**REGULAR MEETING OF THE THIRD LAGUNA HILLS MUTUAL
ARCHITECTURAL CONTROL AND STANDARDS COMMITTEE**

**Monday, November 27, 2017 – 9:30 a.m.
Laguna Woods Village Community Center Sycamore Room
24351 El Toro Road**

NOTICE AND AGENDA

ELEVATION A

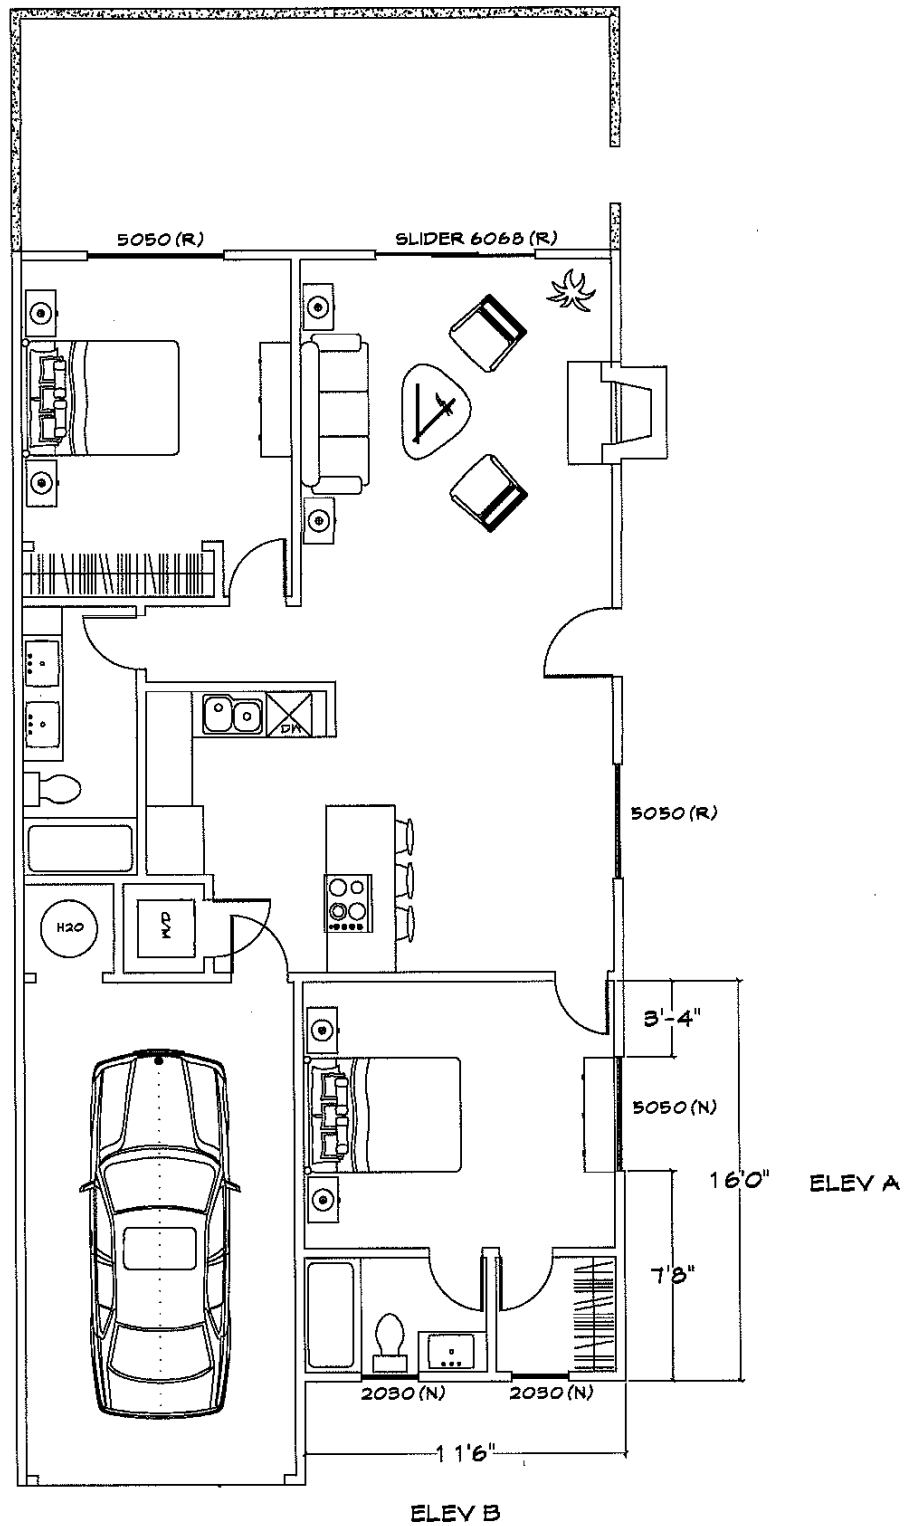
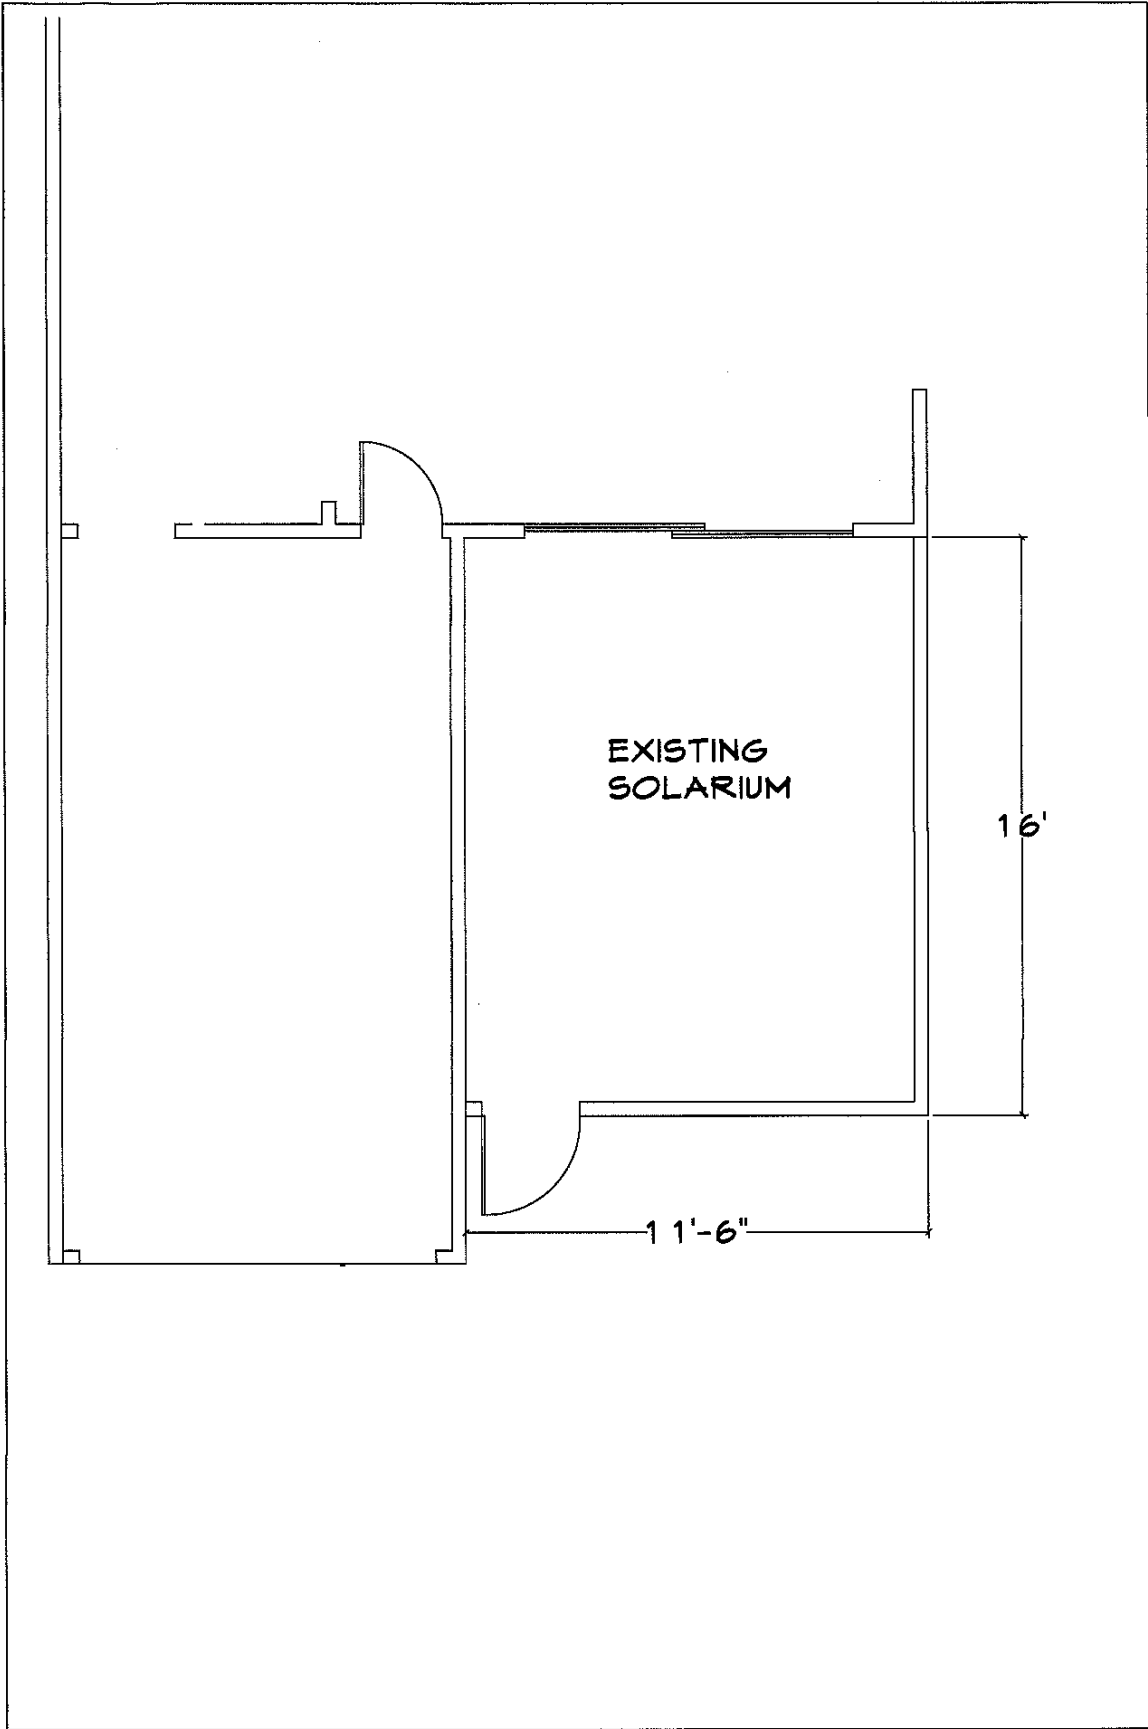
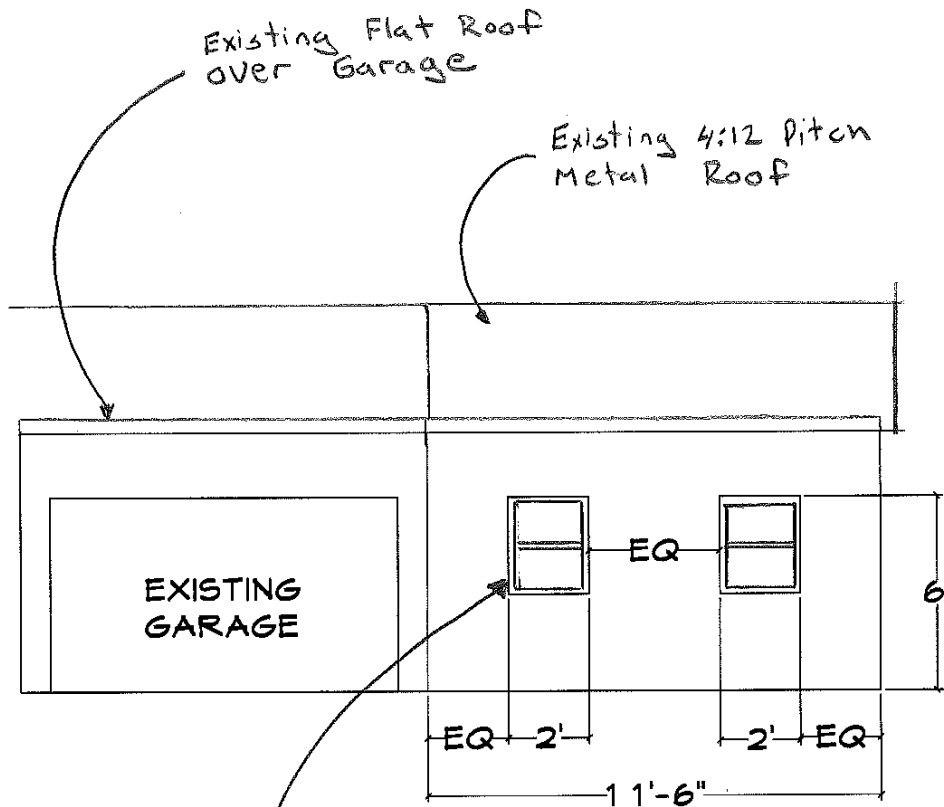
During the variance review, the Committee unanimously decided to postpone making a recommendation to the Board until elevation drawings could be provided that show the proposed roof of the room addition.

(Revised Rear View with 8ft
sliding door and windows all
levelled at the same height)

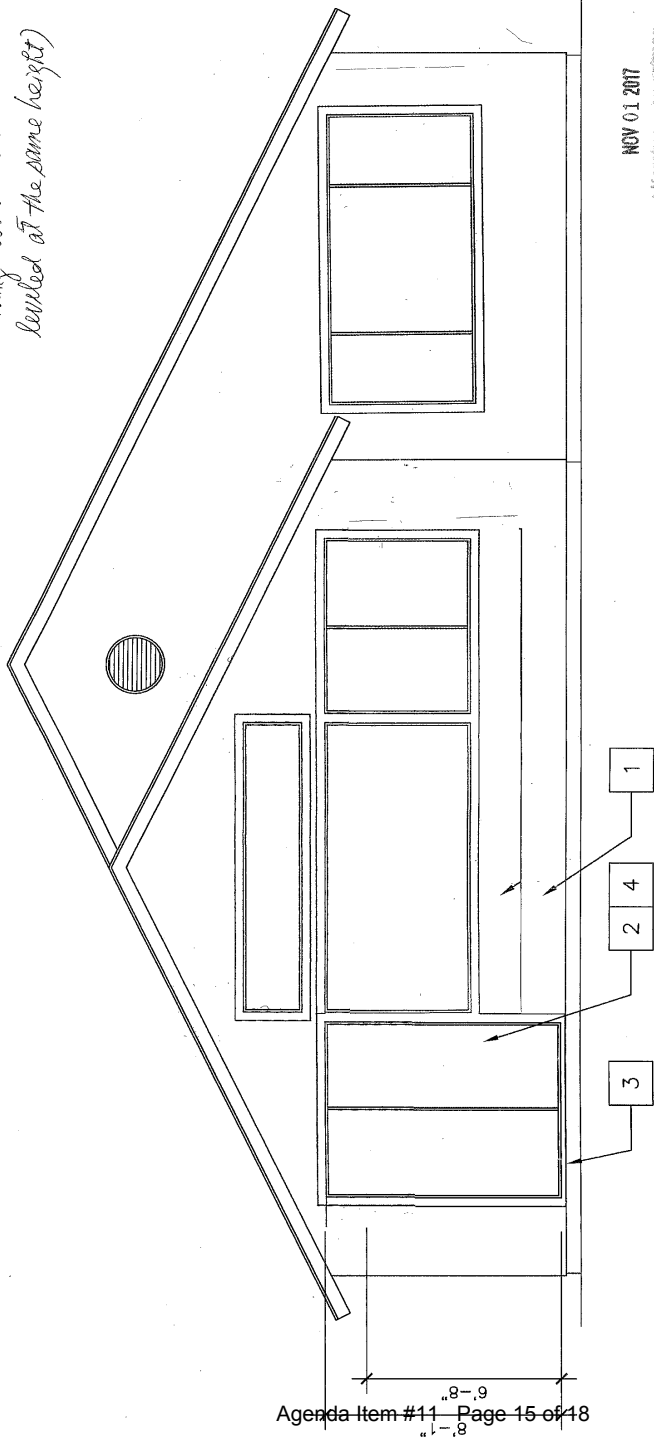
Mr. Jye-Yuh Lee of 5406 Via Carrizo, a San Marco style Manor, is requesting Board approval of his variance to add a second air condenser to the outside of his unit and to modify the height of the French doors on the living room extension that was approved via variance in June 2017. The cost of the proposed alteration would be borne by the member.
